3.5 CRITIQUE OF BELLCORE AVAILABILITY ANALYSES

Figure 1. LMDS Antenna Masks

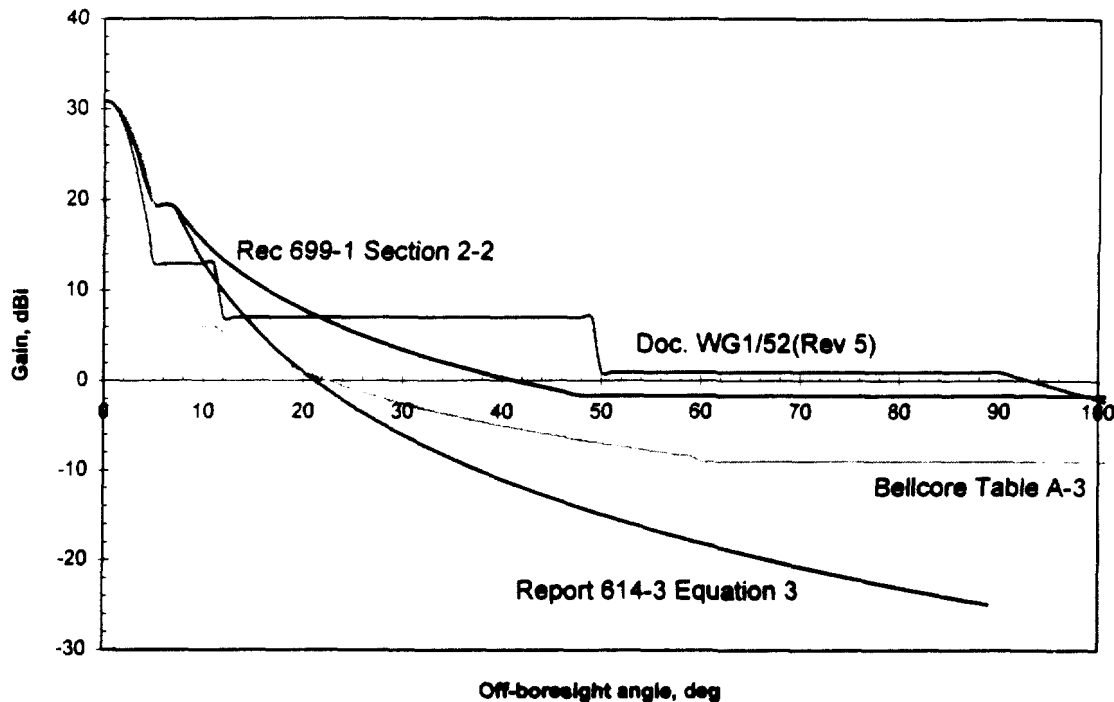
Recommendation ITU-R 699-2 (*Reference Radiation Patterns for Line-of-sight Radio-relay System Antennas for use in Coordination Studies and Interference Assessment in the Frequency Range from 1 to About 40 GHz*) describes the antenna reference pattern for point-to-point terrestrial radio-relay communication systems. Using Section 3 of the Bellcore report to calculate the antenna size in wavelengths (D/λ) from the stated LMDS main-lobe gain of 31 dBi, the LMDS subscriber antenna has a $D/\lambda = 14.6$. Therefore, the relevant antenna mask is the one for $D/\lambda < 100$ found in Section 2.2 of Rec. ITU 699-2, and reproduced in Figure 1.

The standards present several caveats for the use of this pattern. Rec. ITU-R 699-2 states (in Note 2) that since “the radiation pattern may be worse than the reference radiation pattern” due to effects such as feed system spill over, “the Recommendation should not be interpreted as establishing the maximum limit for radiation patterns....” It further states that it applies only to rotationally symmetric antennas (Note 5). The background study to ITU 699-2, CCIR Report 614-3 (*Reference Radiation Patterns for Radio-relay System Antennas*), in equation 3 provides an additional pattern for antennas with very low sidelobes such as offset-fed reflectors—Figure 1 reproduces this pattern). The Report further states that the “weather cover” (the radome) may increase the sidelobe levels, and recommends in Section 5 that for frequency sharing problems, backlobe gains should be assumed to be 0 dBi.

Figure 2. FSS Antenna Masks

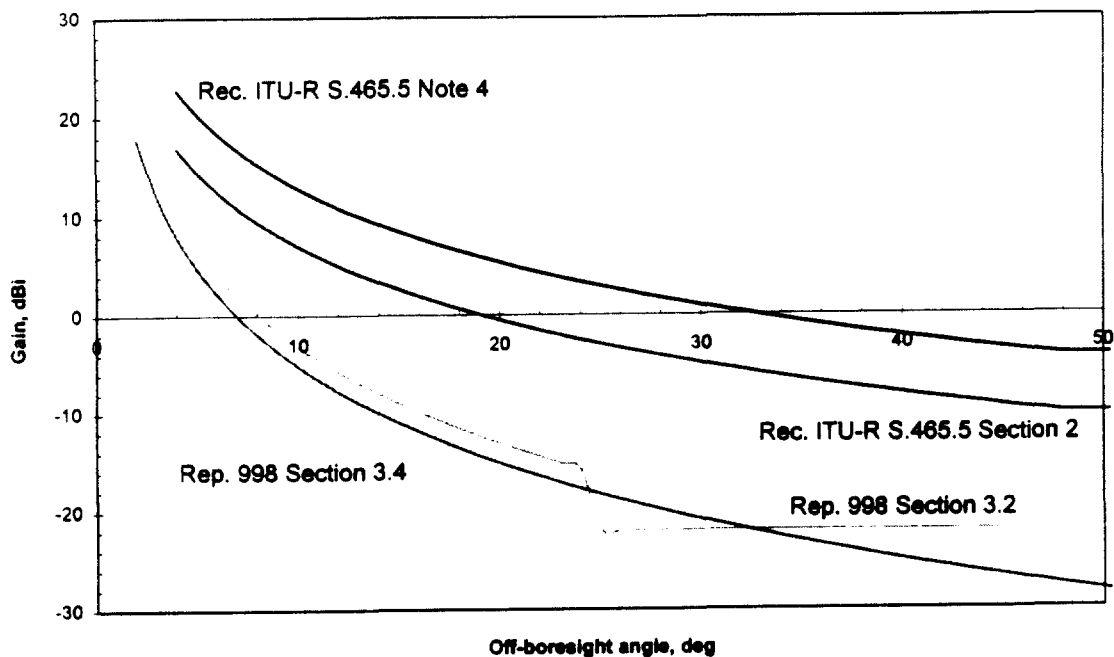
on the TST and TGT main-lobe gains of 36 dBi and 50 dBi, respectively, the TST and TGT antenna sizes are $D/\lambda = 26$ and 130. Since the TST $D/\lambda < 50$, the more liberal mask recommended in Note 4 for small antennas prior to 1993 may be more appropriate for use with the TST. Rec. ITU-R S.465-5 also warns “that at large angles, the likelihood of local ground reflections must be considered”. Figure 2 shows these two Rec. ITU-R S.465-5 patterns.

CCIR Report 998 (*Performance of Small Earth-Station Antennas for the Fixed Satellite Service*) provides advice on how to minimize antenna sidelobes, recommending the use of RF-absorbing material on structures and reflector edges and the control of factors such as beam taper, blockage, spill-over, and phase errors. Using offset-fed, dual-reflector antennas with conic reflectors (Section 3.2) or shaped reflectors (Section 3.4) resulted in improved antenna masks (see Figure 2).
